Sydney Western City Planning Panel Briefing Report

Panel Reference	PPSSWC-319
DA Number	DA-19/2023
LGA	Liverpool City Council
Proposed Development	Demolition of existing structures and construction of a three-storey centre based childcare centre over basement car parking accommodating 124 children
Street Address	73 Lachlan Street Warwick Farm
Applicant	FLDC Architects
Owners	Ben Nicholas Clint Biggs Robert Noyes
Number of Submissions	2 objections (1 containing a petition with 4 signatures)
Regional Development Criteria (Schedule 6 of the SEPP) Planning System) 2011	Private infrastructure and community facility over \$5 million – childcare centre
Prepared by	Nelson Mu Fineline Planning & Design on behalf of Liverpool Council

Figure 4 – 2 levels of basement carpark

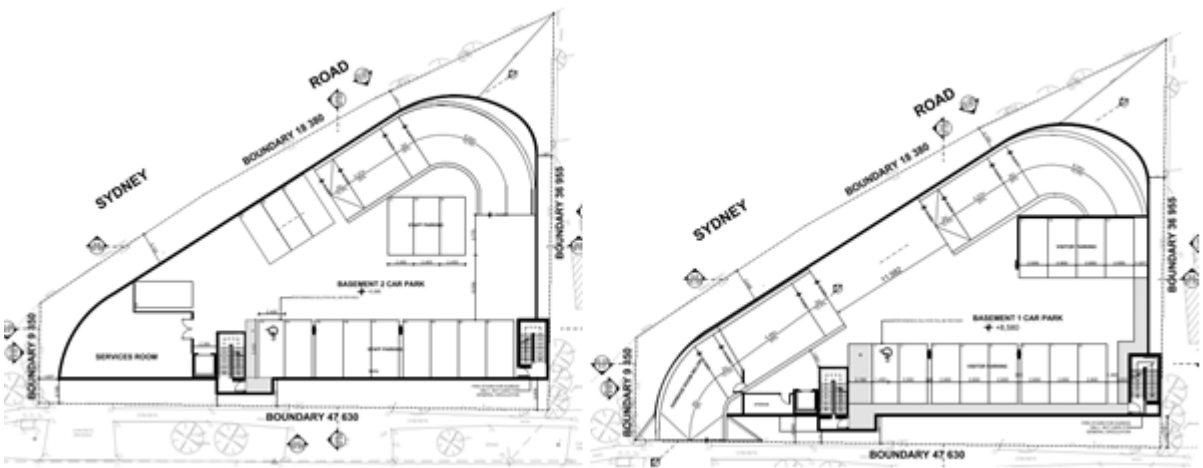
- Basement level:
 - 842m² / 1,150m² = 73%
 - The extent of site coverage proposed provides for minimal area for mature height trees to be planted in the development especially within the Hume Highway setback area.

Figure 6 – First-floor plan (outdoor children play area for 2-6 years old is fully enclosed)

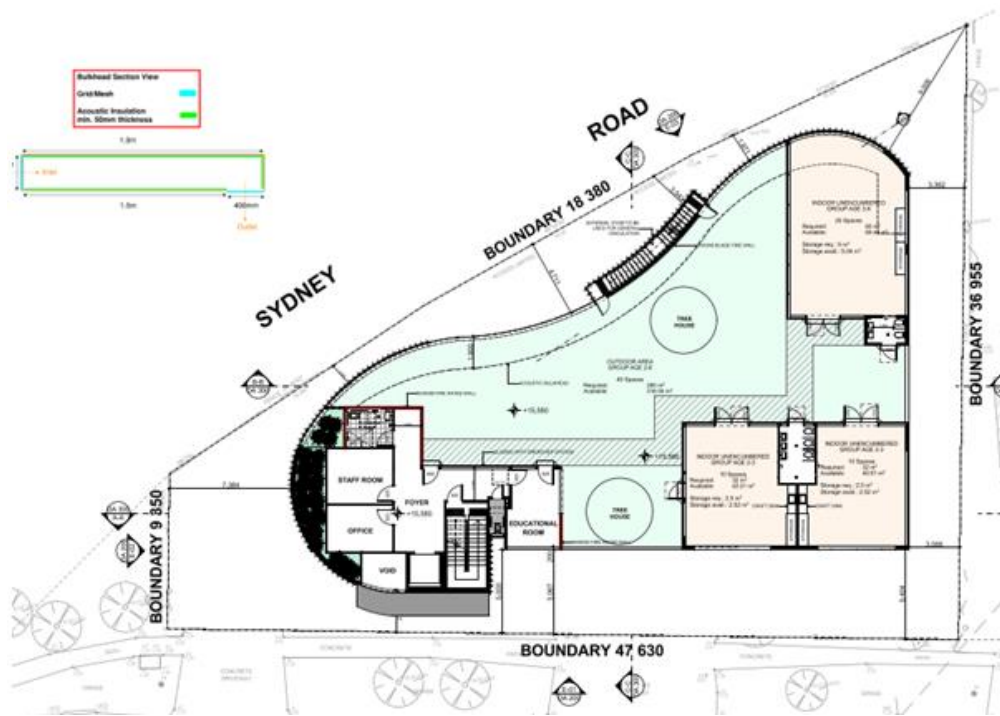
Having regard to noise attenuation recommendations provided within the acoustic report, the proposed outdoor space is required to be fully enclosed at Levels 1 & 2, and thus may not constitute outdoor space. In this regard, the outdoor space on these levels would constitute 'simulated outdoor environment'. Whilst this may be appropriate in the circumstances, particularly given that access to unencumbered outdoor space at ground level is available, concurrence from the Regularly Authority (acecqa) would be required in accordance with Part 3.22 of SEPP (Transport and Infrastructure) 2021.

Acoustic Barrier

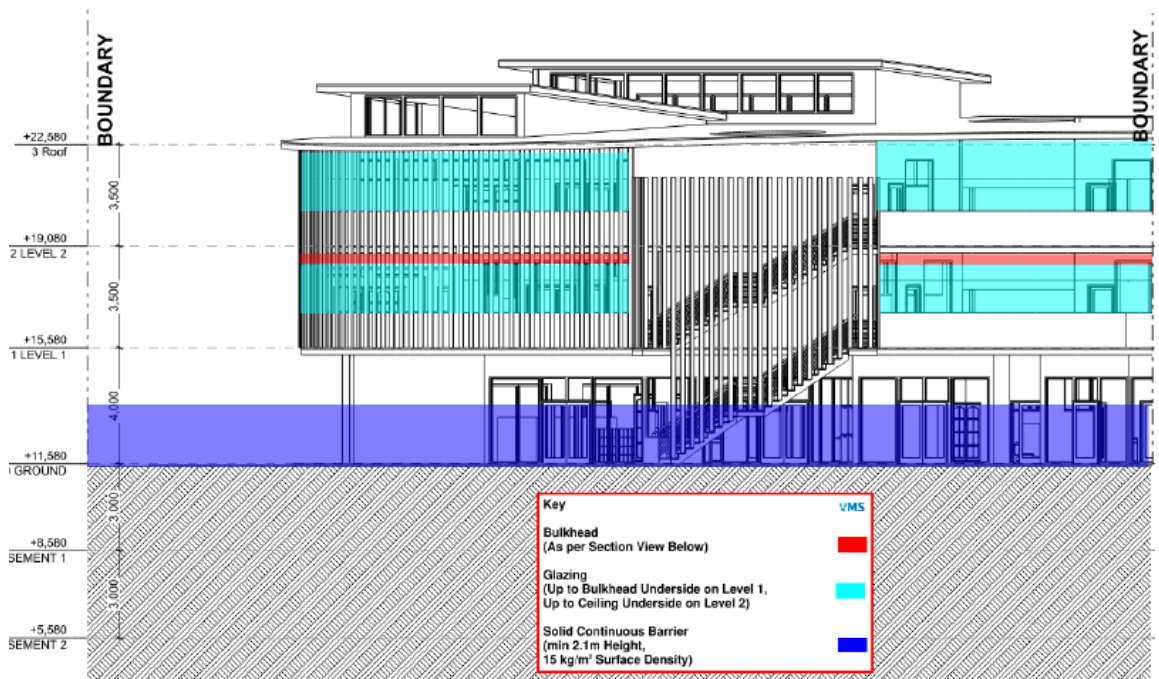
The acoustic report provided with the application requires a 2.1m continuous barrier along the boundary to Sydney Road which would present poorly to the approximately 55m street. This continuous fencing should be further articulated with landscaped areas to break up the blank barrier. Consideration of alternative designs for 2.1m acoustic fencing between the site to the east to reduce any amenity impacts.
